To All Lamborghini Dealers and Licensed Service Point  
From Customer Service Department  
Subject Rework for the setscrew of the rear bonnet  
Group LB715.8.27  
Attachments -  
Date 01.06.2006  
Pages 7

Rework for the setscrew of the rear bonnet.

All MY '06 Gallardo Spyder from VIN 2623 until VIN 3836.

Pict. 2

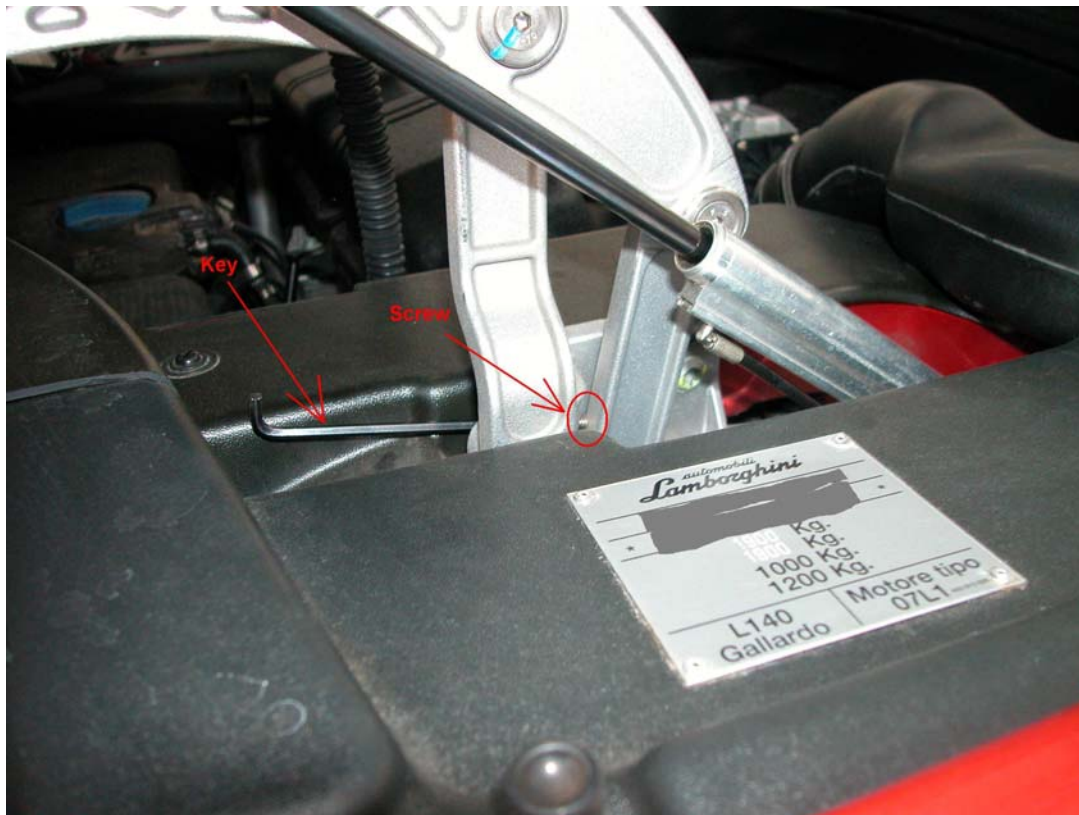
- 1.2 Adopt all precautions to work safe and prevent car damages.
- 1.3 Open the rear bonnet in service position.
- 1.4 Find the setscrew on the arms of the rear bonnet and unscrew it, as in picture 2 and 3.

Pict. 4

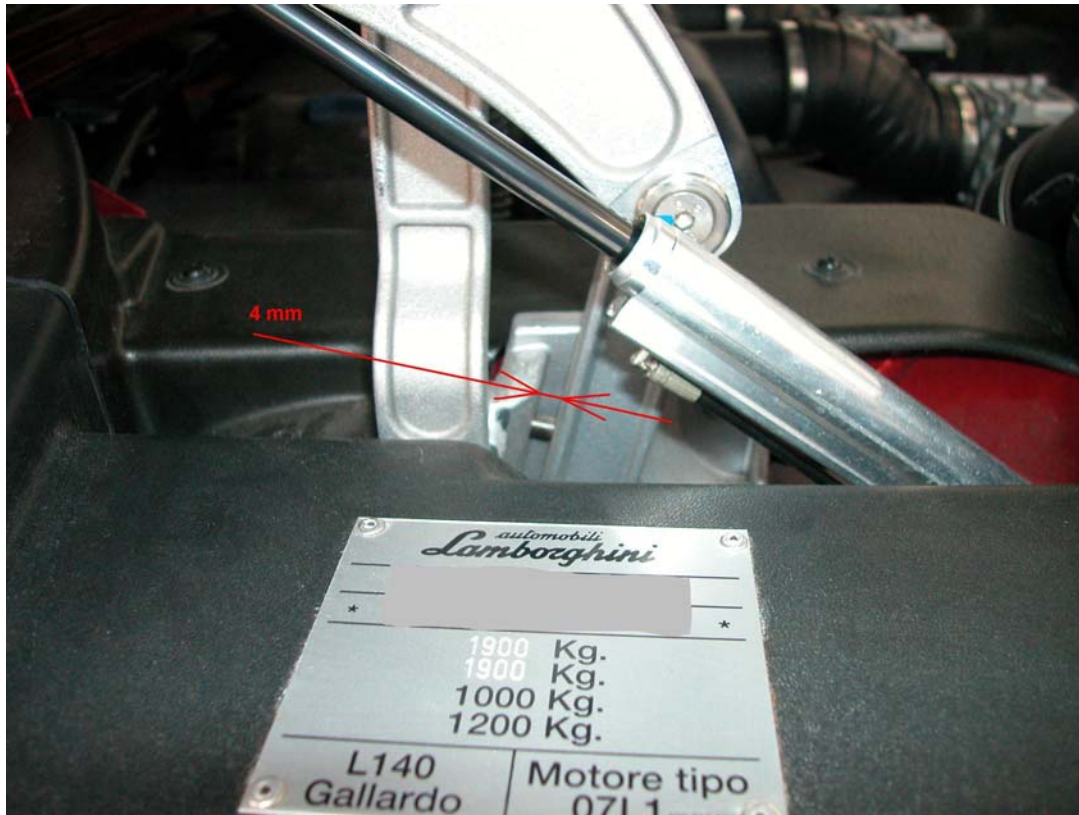
- 1.5 If the screw is loosened, unscrew it completely.
- 1.6 Use Arexons breaking thread 52A43 or Loctite (blue stuff) solution on the thread of the setscrew and reassemble it.
- 1.7 The setscrew should be about 4 mm out of the arm as in picture 4.
